Title **Banana Pro**
Size A3 Document Number CPU1 Rev 1.1
Date: Thursday, August 22, 2013 Sheet 5 of 18

20140916:change Version to V1.1

HDMI-CSI

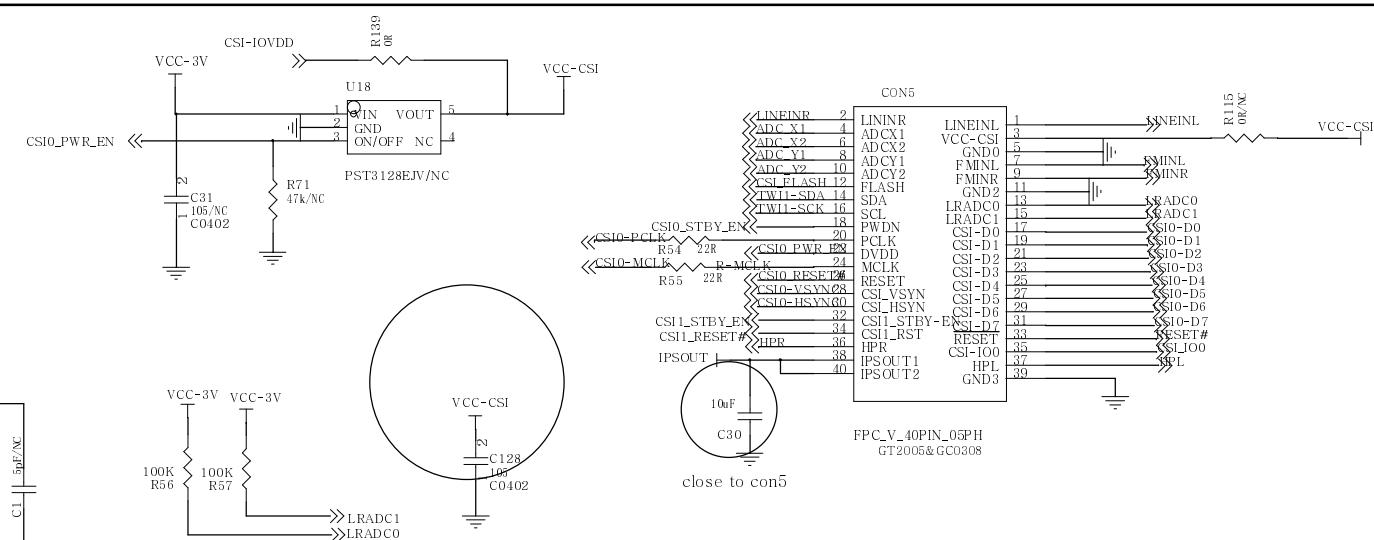
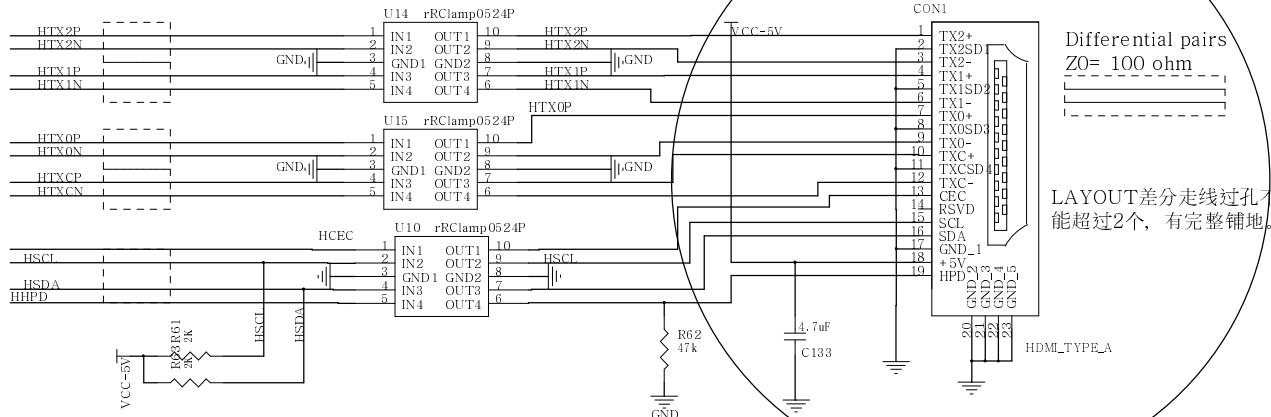
20140916: change HDMI to Type A
